ADDENDUM NUMBER THREE (3)**CATAWBA COUNTY****BLACKBURN RESOURCE RECOVERY FACILITY OPERATOR'S BUILDING****PROJECT NO. 26.00701**

This Addendum Number 3 (Three) is issued this the 28th day of October 2026, to all parties who hold a set of Bid Documents for the project entitled: “**BLACKBURN RESOURCE RECOVERY FACILITY OPERATOR'S BUILDING**”. This Addendum Number 3 (Three) shall become part of the Contract Documents and its receipt acknowledged on the bid documents at the time of bidding.

2
S101 ROOF FRAMING PLAN
SCALE: 1/4"=1'-0"

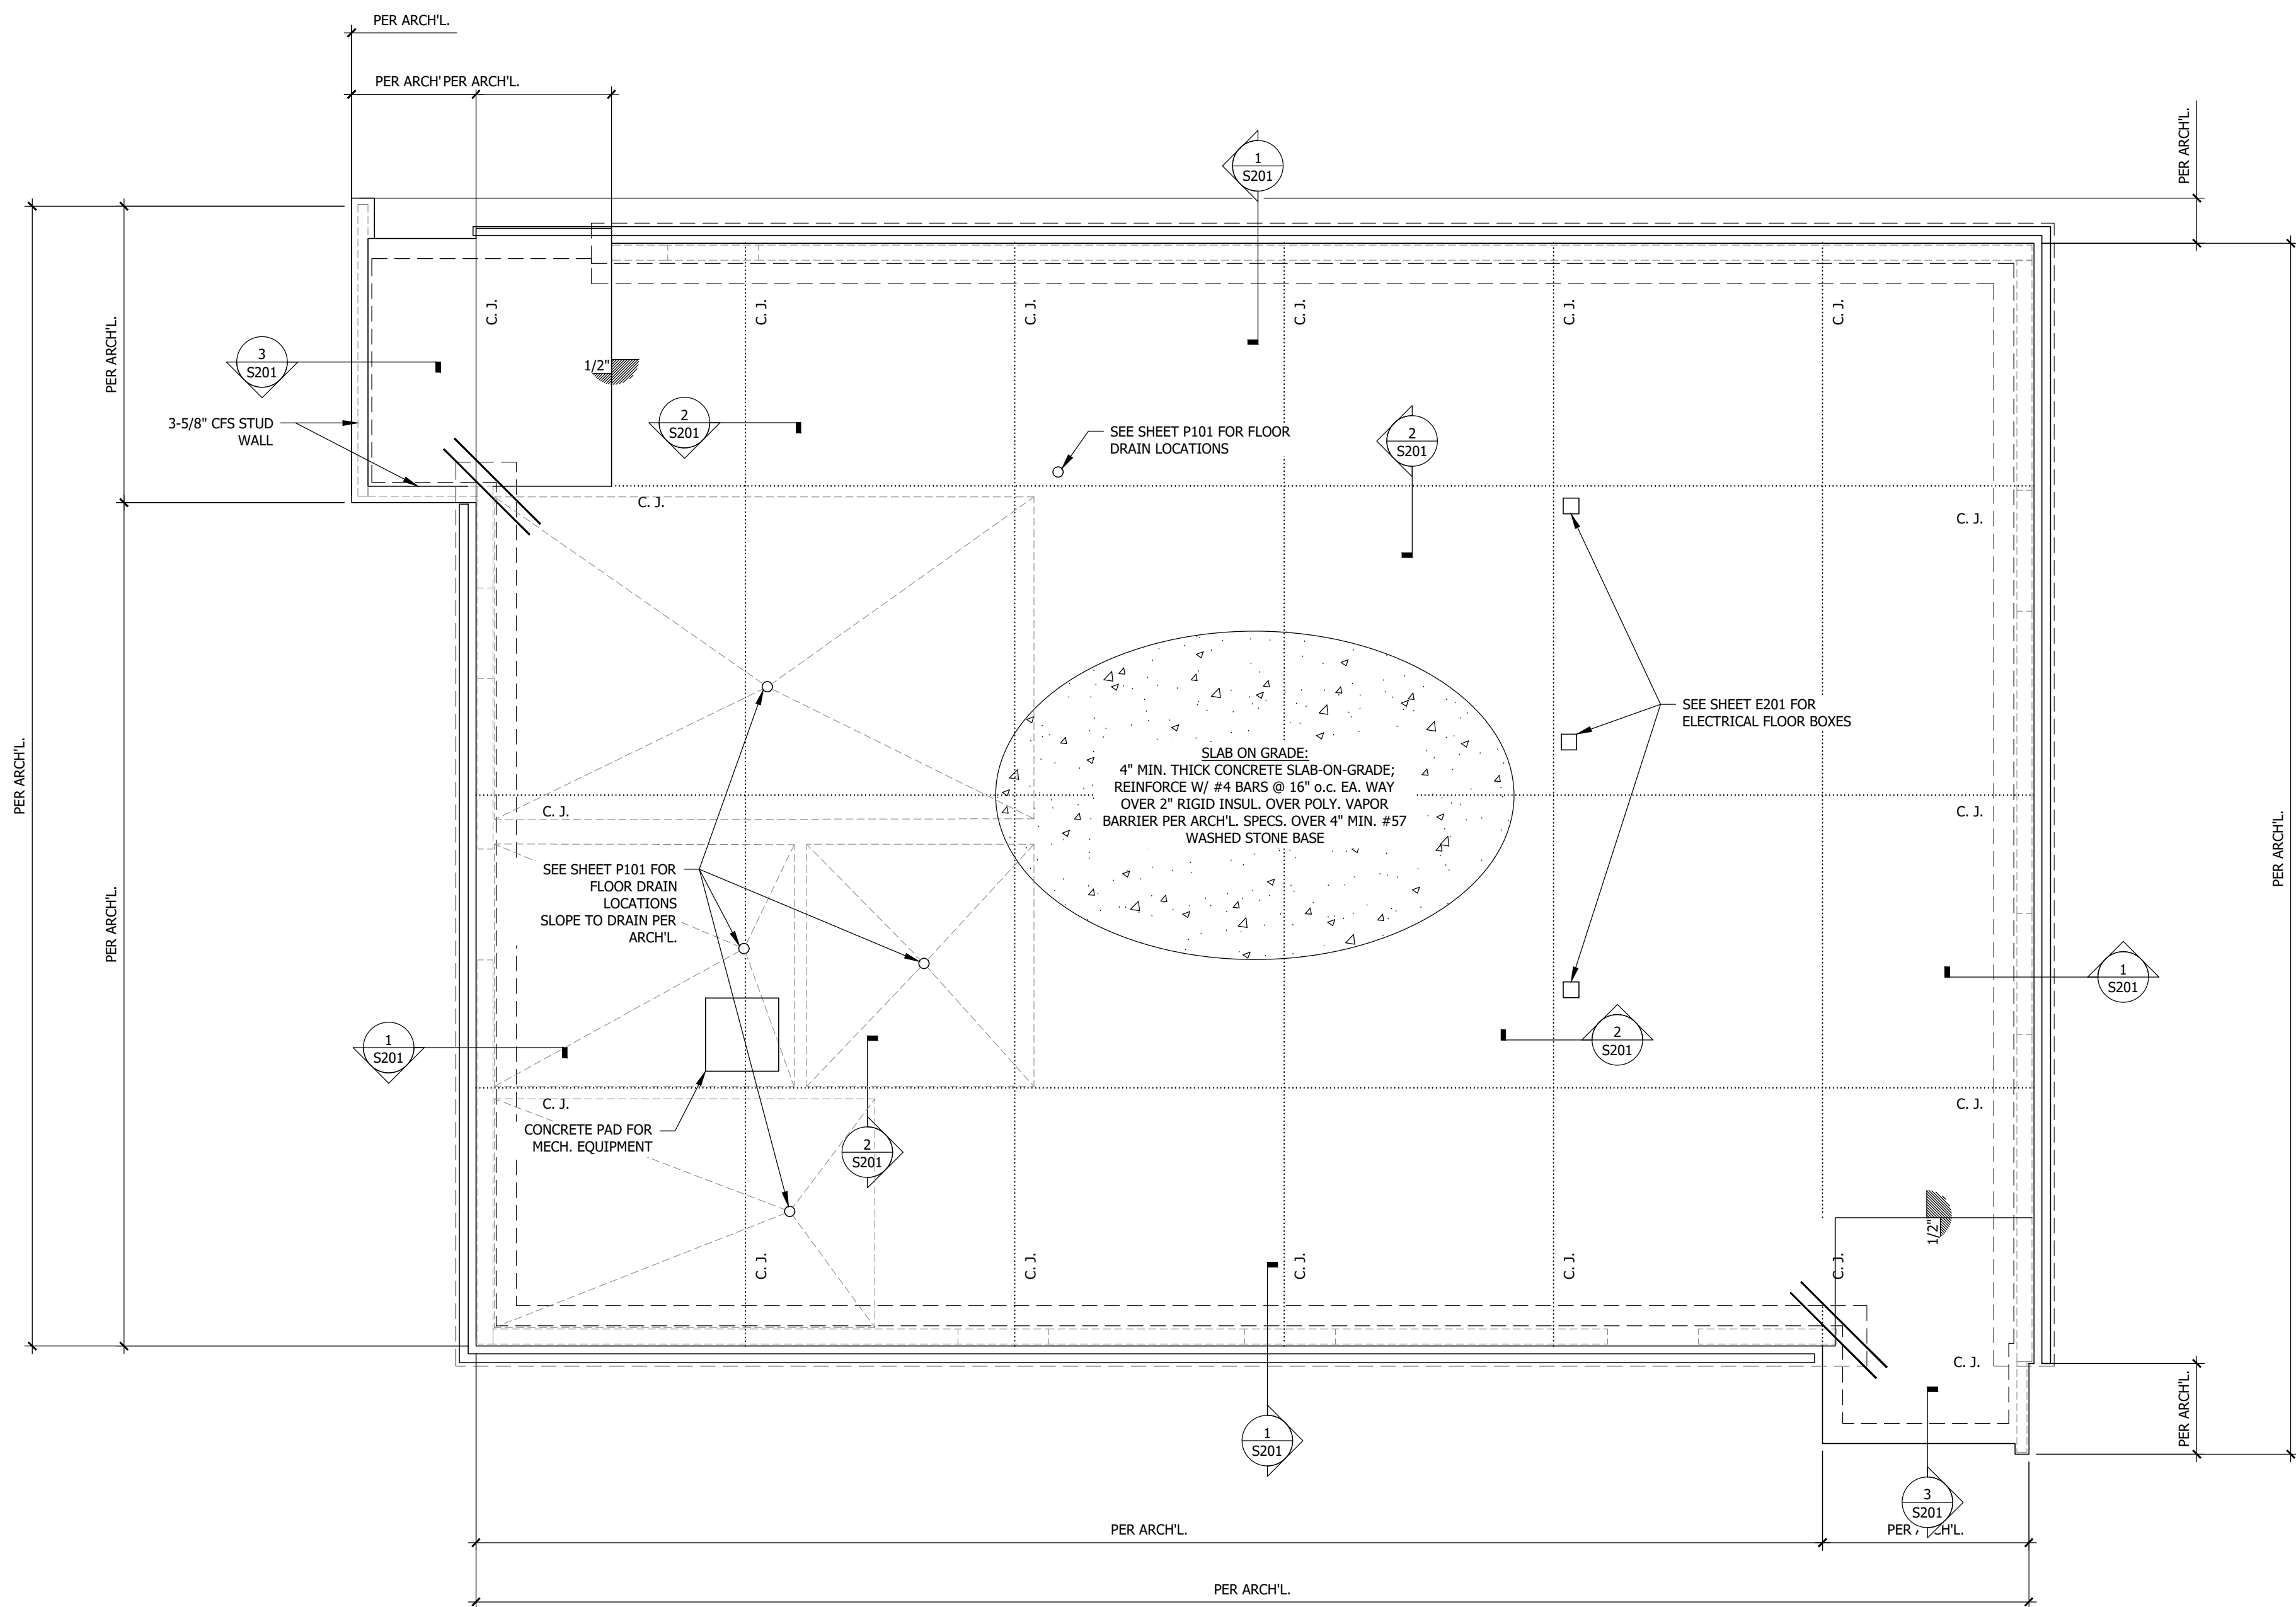
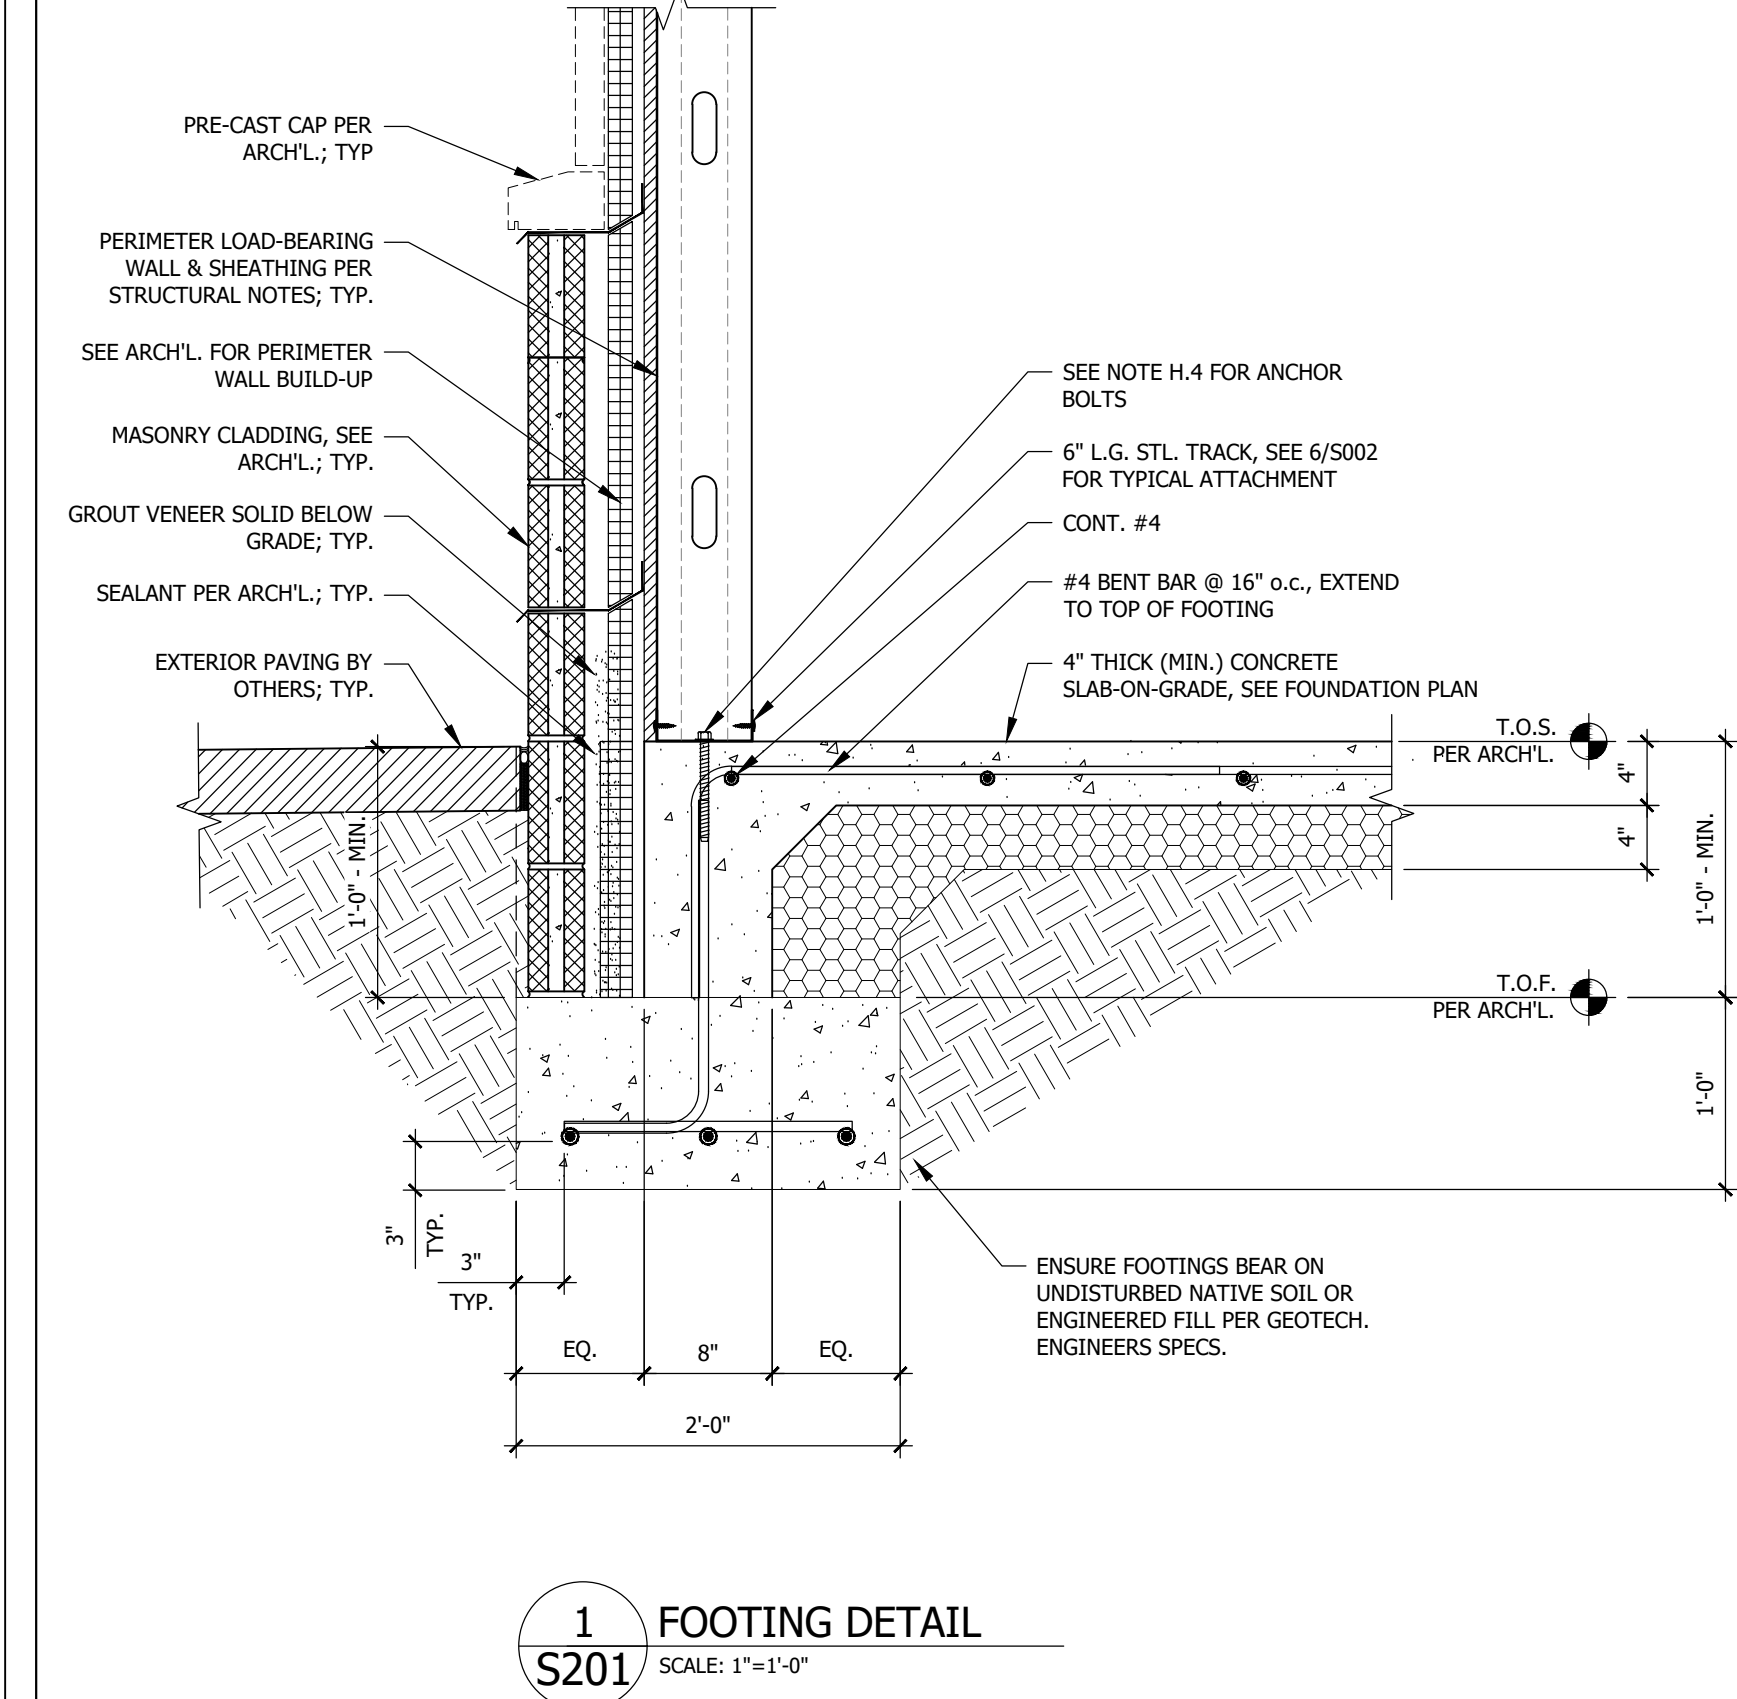
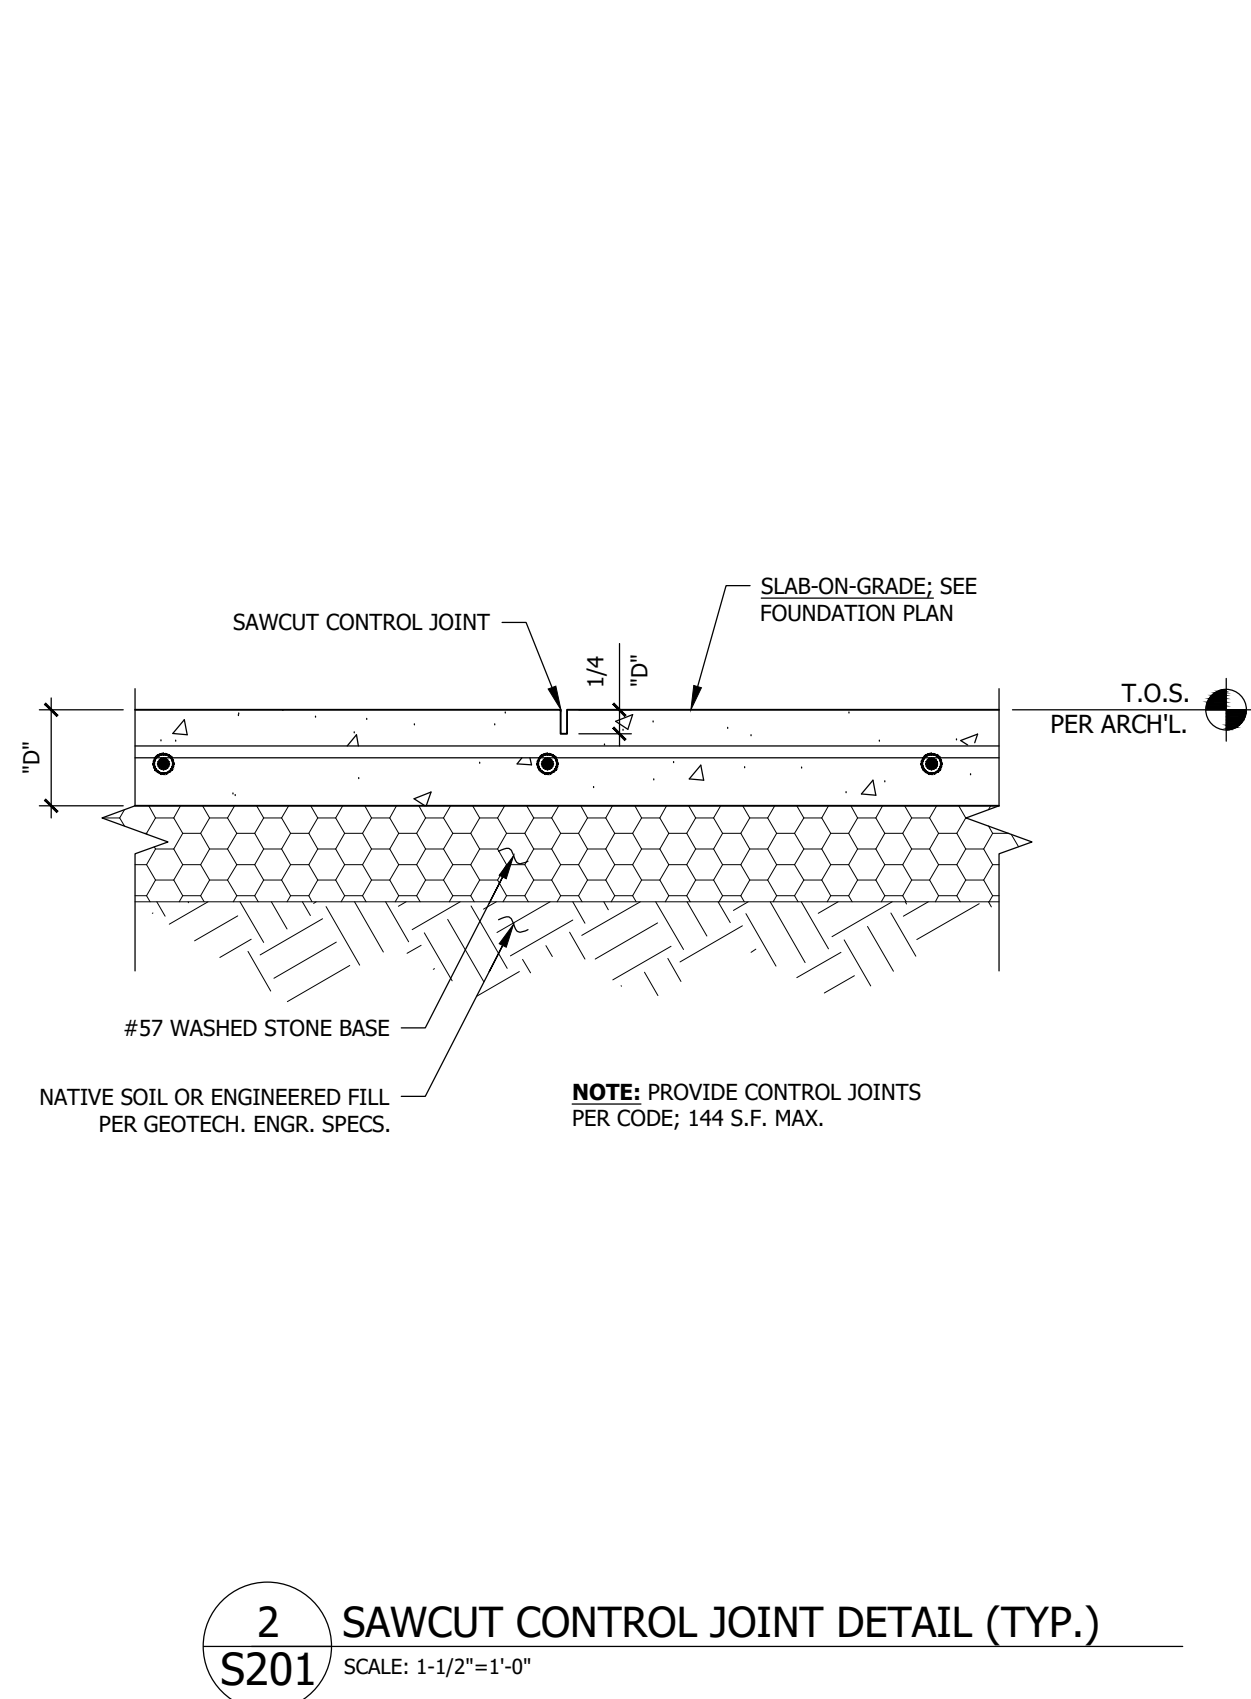
14. On plan sheet S-101, framing note #1, there is a shearwall schedule noted to be on plan sheet S0.3. There is not a shearwall schedule in the structural plans, and we could not find one anywhere in the plans. Could someone please let us know where the shearwall schedule is located.

30. Missing shear wall schedule and details: Sheet S101 references Sheet S0.3 for the plywood shear wall schedule, hold-down requirements, and strapping details. Sheet S0.3 was not included in the provided structural drawing package. Please provide the missing schedule and details, including shear wall locations, sheathing requirements, hold-downs, and strapping. (Reference: S101, Framing Plan Notes 1–3)

- a. Upon consideration, the shearwall note will not be applicable on this project. The steel track shall be attached to the slab per Note H-4 ($\frac{1}{2}$ " diameter x 6" Titan

screws at 32" on center). Structural sheets have been revised to reflect this clarification.

- a. Our reference notes have been corrected. No designated shear walls required for this building.

- FRAMING PLAN NOTES:
- NO DESIGNATED SHEAR WALLS ARE REQUIRED FOR THIS PROJECT.
 - ALL PERIMETER LOAD-BEARING WALLS AND SHEAR WALLS STUDS ARE TO BE FULL HT. AND SHALL BE BALLOON FRAMED FROM PLATE TO PLATE, THERE SHALL BE NO SPLICES AT CEILING JOISTS.
 - TYPICAL PERIMETER LOAD-BEARING EXTERIOR WALL STUDS SHALL BE 600S162-54 W/ 600T150-54 TRACK.
 - SEE ARCH'L DRAWINGS FOR ALL WINDOW AND DOOR OPENING LOCATIONS AND REQ'D. ROUGH OPENING SIZES; TYP..
 - SEE ARCH'L FOR INTERIOR PARTITION WALL TYPES AND LOCATIONS; U.O.N. TYP.
 - VERIFY ALL WALL PLATE ELEVATIONS WITH ARCH'L DWGS.
